Re: Application by Vincent Wan for Rezoning at 9571 Williams Road from  
Single-Family Housing District, Subdivision Area E (R1/E) to Single-Family  
Housing District (R1-0.6)

RZ 07-370649

Staff Recommendation

**PROPOSED SITE PLAN**  
**9571 WILLIAMS ROAD**

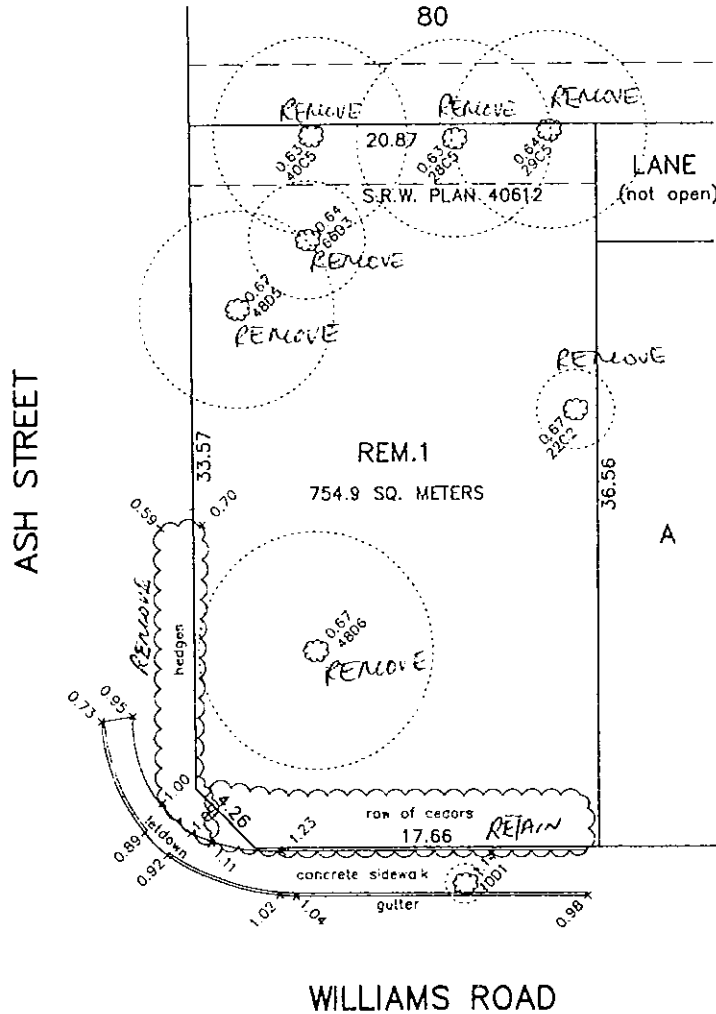
- A tree survey is submitted (**Attachment 4**) and seven (7) bylaw-sized trees are noted on site.
- An Arborist Report (**Attachment 5**) is submitted in support of the application. The Report recommends removal of the bylaw-sized trees on site.

- Tree Preservation Group staff have reviewed the Arborist Report and concurred with the recommendations for tree removal on the basis of tree condition and conflict with proposed development plans and lane construction.

**PROPOSED RESIDENCE  
9571 WILLIAMS ROAD  
PLANTING PLAN:  
(WITH GRADING NOTES)**

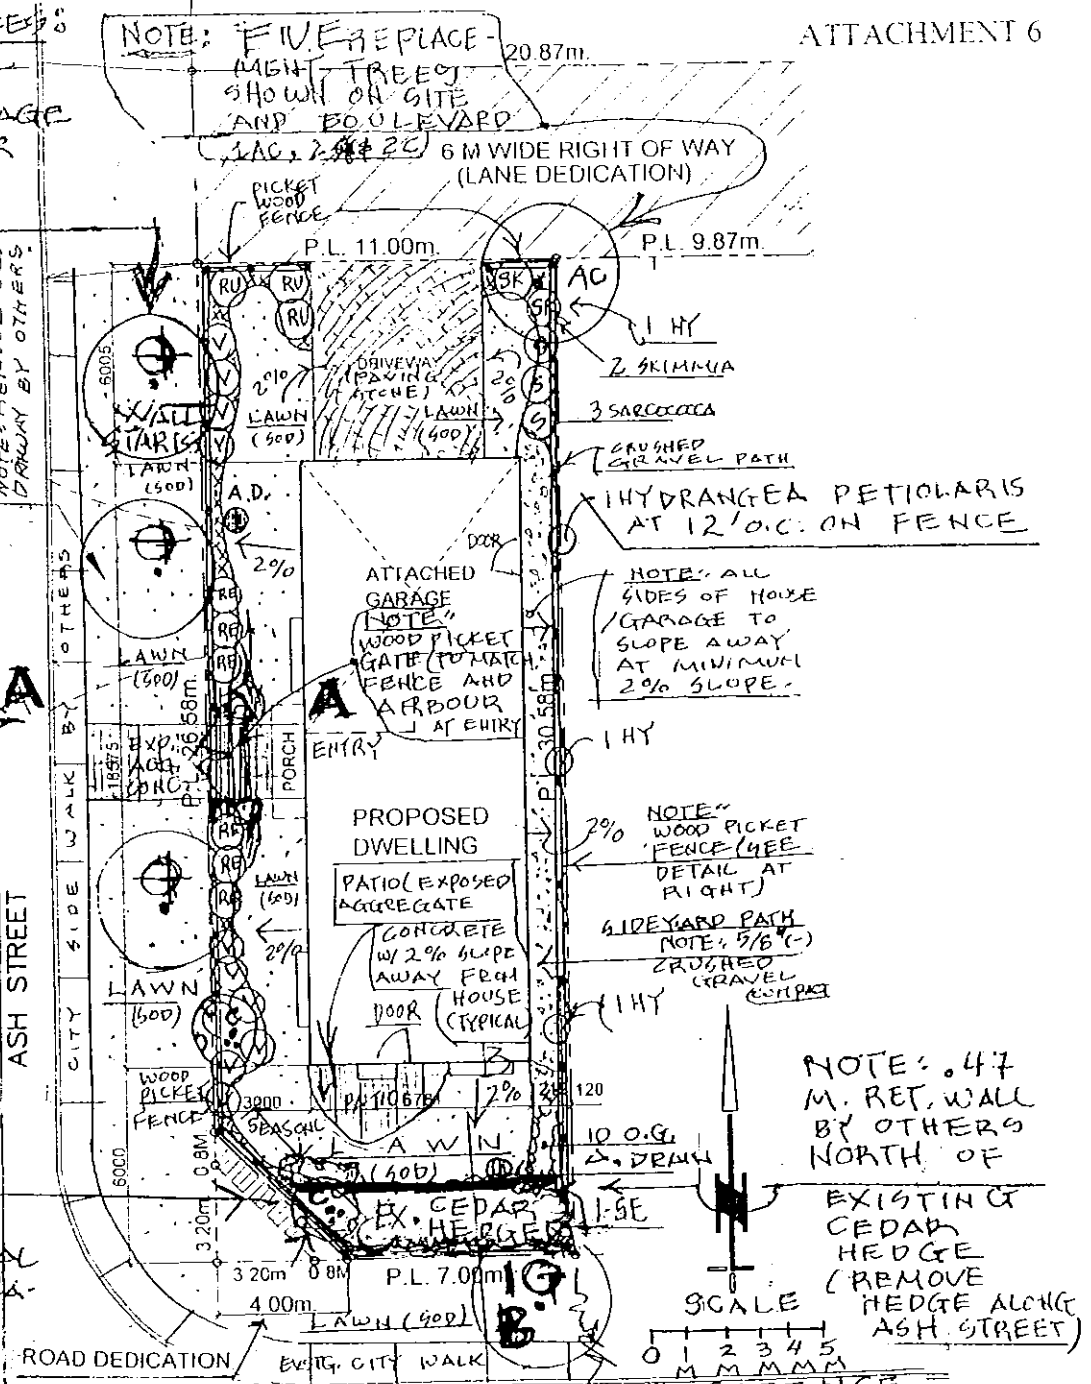
- two (2) trees of 11 cm;
  - four (4) trees of 9 cm;
  - two (2) trees of 8 cm; and
  - six (6) trees of 6 cm.
- To illustrate how the front and side yard of the future corner lot will be treated, the applicant has submitted a preliminary Landscape Plan, which includes five (5) of the required replacement trees (**Attachment 6**).

- As a condition of rezoning, the applicant must submit a final Landscape Plan, prepared by a registered landscape architect, for both of the future lots and a landscaping security based on 100% of the cost estimates provided by the landscape architect.

- If replacement trees could not be accommodated, on-site cash-in-lieu (\$500/tree) for off-site planting would be required;
- As a result of the frontage works required along Ash Street, a row of hedges located within the city's boulevard along this frontage will be removed. Parks Operations Section has no concerns on the proposed removal.

1. Submission of a landscape plan prepared by a registered landscape architect to the satisfaction of the Director of Development and deposit of a landscaping security based on 100% of the cost estimates provided by the landscape architect. The landscape plan and landscaping security should include the 14 replacement trees required (2 replacement trees each at 11 cm calliper or 6.0 m tall, 4 replacement trees each at 9 cm calliper or 5.0 m tall, 2 replacement trees each at 8 cm calliper or 4 m tall, and 6 replacement trees each at 6 cm calliper or 3.5 m tall). If replacement trees could not be accommodated, on-site cash-in-lieu (\$500/tree) for off-site planting would be required;

**PRELIMINARY ELEVATIONS  
WEST LOT -9571 WILLIAMS ROAD**

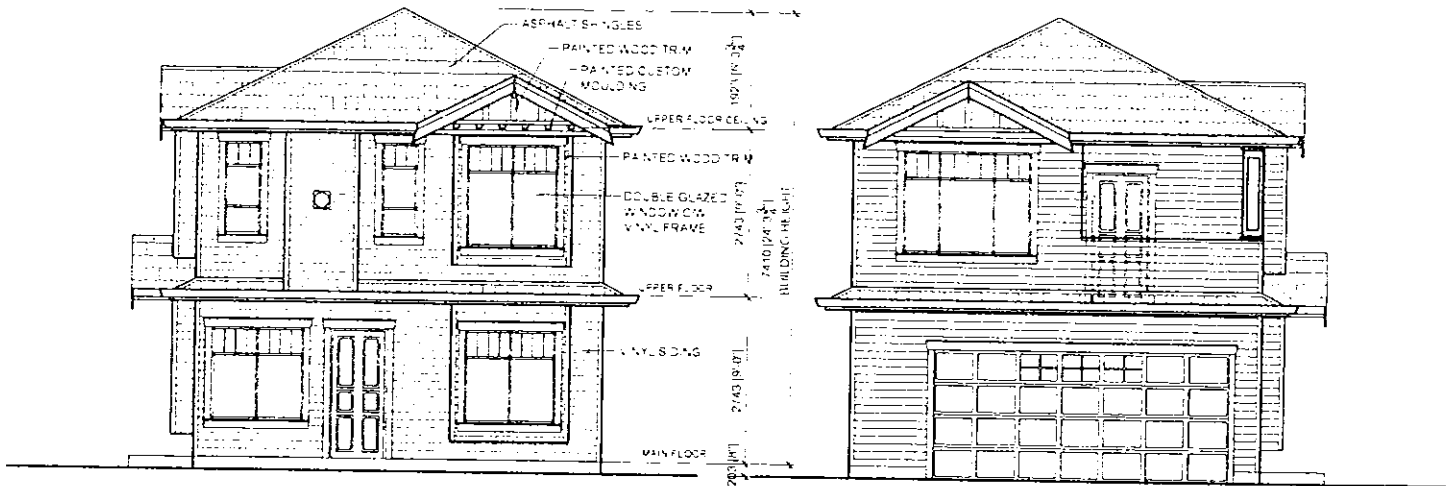
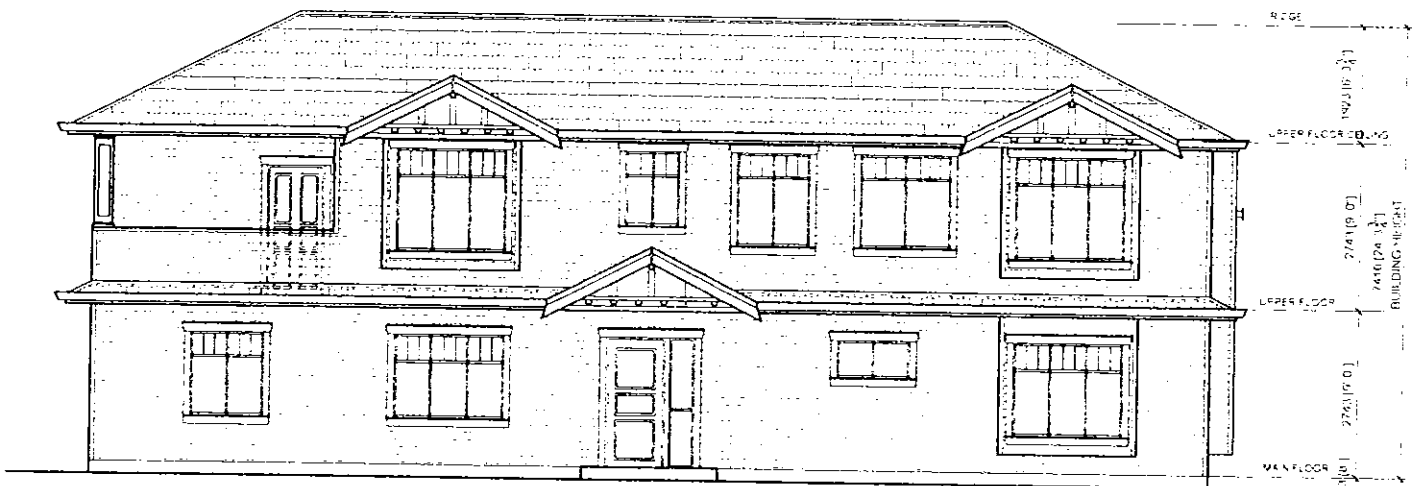
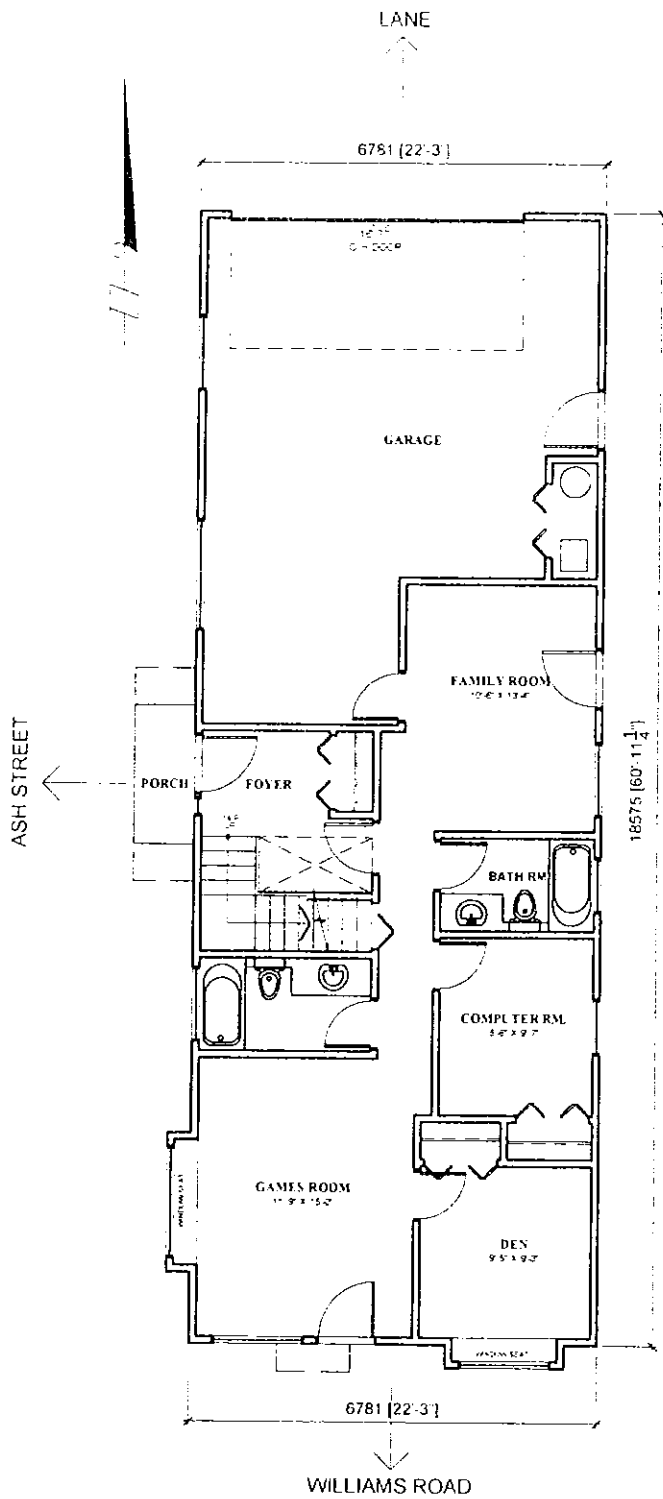
- To illustrate how the future corner lot interface will be treated, the applicant has submitted a set of preliminary Building Elevations (**Attachment 7**). At future development stage, Building Permit plans must be in compliance with zoning.
